FIRST REVIEW
WC³ Project #: 217-525-128

Subject: Signature Homes – Plan Review Comments

Project Name: Signature Homes

Location(s): Horizon, Summit Powder Mountain, Weber County, UT

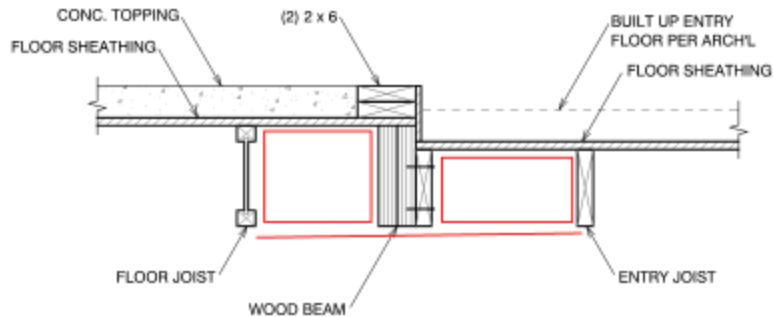
- S1. Sheet S2.2 and S4.2: Callout 7/S4.2 on S2.2 does not appear to be applicable. Please verify if 7/S4.3 was the intended detail. Please revise as required. Please see IBC 107.
- S2. Sheet S4.1:
- A. Detail 7 shows a stepped diaphragm condition. Additional straps may be required to transfer the loads between levels. Please verify and revise as required. Please see ASCE 7 1.4, 12.1.3, 12.10 and 12.11.2.2.

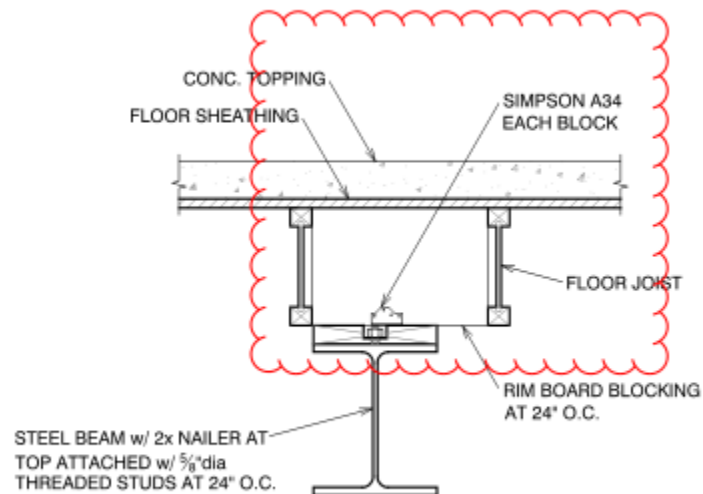
- B. Detail 8 shows a stepped diaphragm condition. Additional straps and blocking may be required to transfer the loads between levels. Please verify and revise as required. Please see ASCE 7 1.4, 12.1.3, 12.10 and 12.11.2.2.

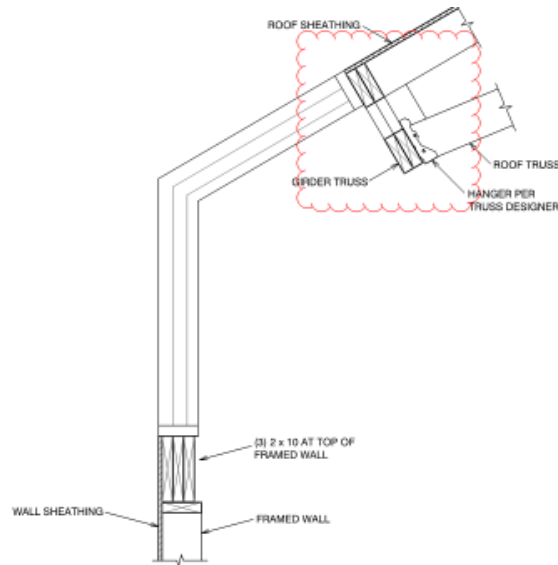
- S3. Sheet S4.2: Detail 8 shows a Simpson A34 clip transferring shear forces to beam below. If the intent is to transfer forces parallel to the joists direction, please note that the A34 is suitable for out of the page direction. Please verify and provide a second A34 on the other side to account for into the page forces. Please see IBC 107, 1604 and Simpson's catalog.

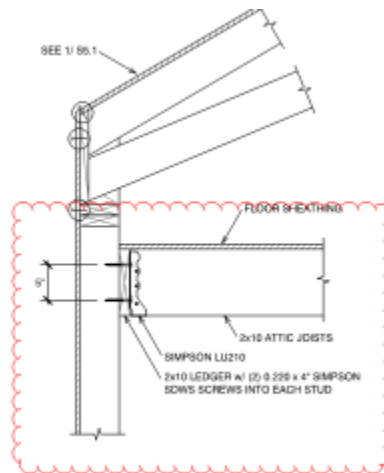
- A. Detail 2 called out on S2.3 seems unclear. On S2.3 roof truss and girder truss are parallel. On S5.1 they are perpendicular. The header truss may have been mislabeled as girder truss and the girder truss may be mislabeled as roof truss. Please verify and revise as required. Please see IBC 107.

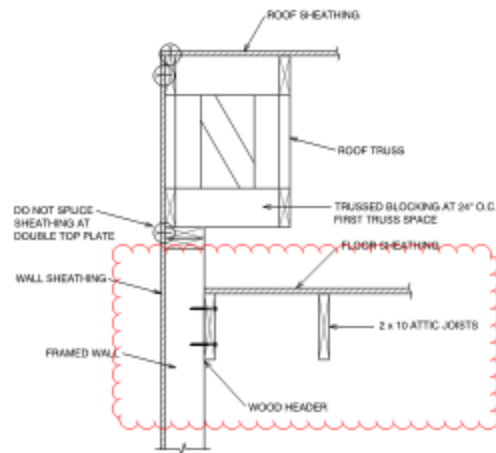
- B. Detail 5 shows a ledger condition that potentially may experience cross grain bending. Please verify and consider tension device directly to the framing members. Please see ASCE 7 12.11.2.2.3.
